City of Richmond

# **Development Permit Panel**

Council Chambers Wednesday, January 11, 2012 3:30 p.m.

#### 2. Development Permit 10-545704 (File Ref. No.: DP10-545704) (REDMS No. 3420906)

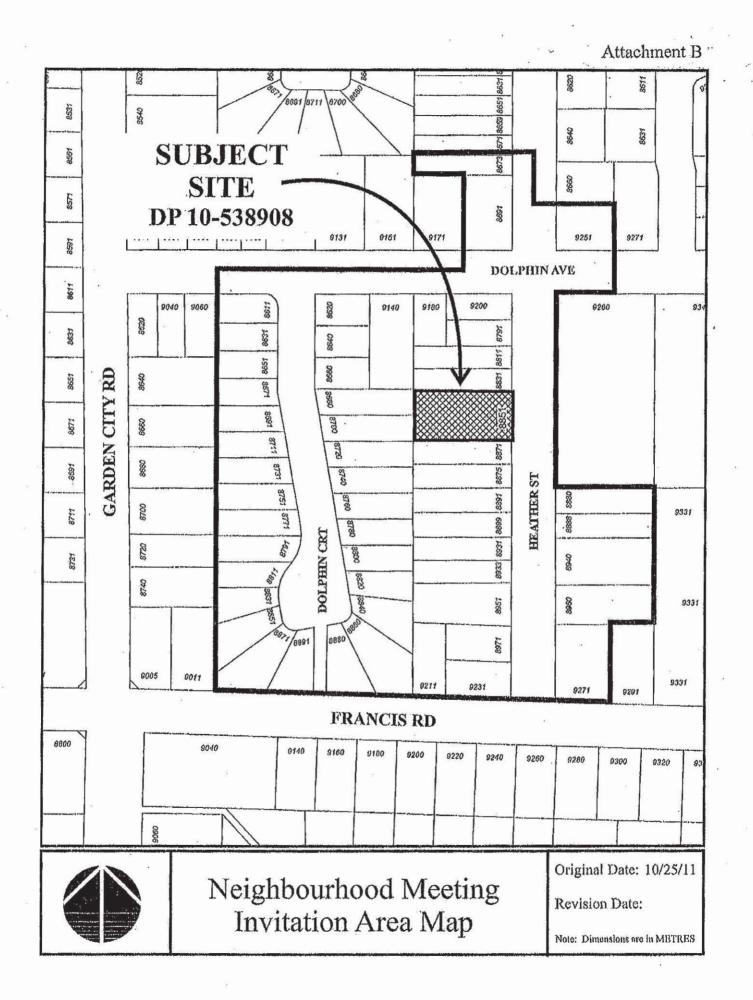
- substantial changes have been made to the project in response to Panel's comments; wider space at the back of the building; richer treatment of surfaces both at the front and back of the building; appreciate decorative and permeable pavers at the parking stalls; playful attitude towards the lane is a great idea; bollards are a nice idea;

- rubberized curb would be a more appropriate approach than timber edge along the curve Vertical timber rounds are proposed to address curves;
- consider carrying the unit paving across the entrance area to provide a sense of entry Incorporated;

- consider planting a row of trees along both side yards of the parking area; trees will provide cooling to the parking area during summer - Tree planting incorporated on both sides;

- playful area at the back of the building; concern on the smallness of the sandbox and lawn areas; consider larger and more useful areas such as planting or exploring area Outdoor activity areas sized and designed in consultation with licensing;

- consider opportunities for infiltration in the gravel side yards; consider introducing swales Gravel bed is permeable;
- provision for planting at the second level deck is a good idea; consider providing more
  opportunities for children activities Open deck design allows for flexible use;

- consider introducing elements to identify the building as a day care facility; signage at the entry roof portico can provide identification - Signage will be provided through separate sign permit;

- consider redesigning the two windows above the main entry portico to add a daycare character to the building; use of colour and/or introduction of play elements will introduce a sense of whimsy appropriate for a day care;

- consider vertical posts on the side of the building to provide opportunity for a tent/covered space to create more play opportunities for children during the rainy season - Not incorporated due to guard rail post structural limits and building envelope concerns;

- relocating deck from the back of the building to the south is a good gesture; gracious
  interface with the neighbour at the south side;
- front of the building is still a bit harsh as it is a wholly paved parking lot Parking area appearance improved with permeable pavers and tree planting at edge;

- concern on shape of the toddler rooms; narrow and deep; not ideal;
- appreciate the changes made by the applicant; a big improvement compared to the previous presentation; and

- consider introducing something at the street level to help identify the project as a daycare facility, e.g., signage, fencing, or other types of identifiers - As noted above, signage will be incorporated through separate sign permit.
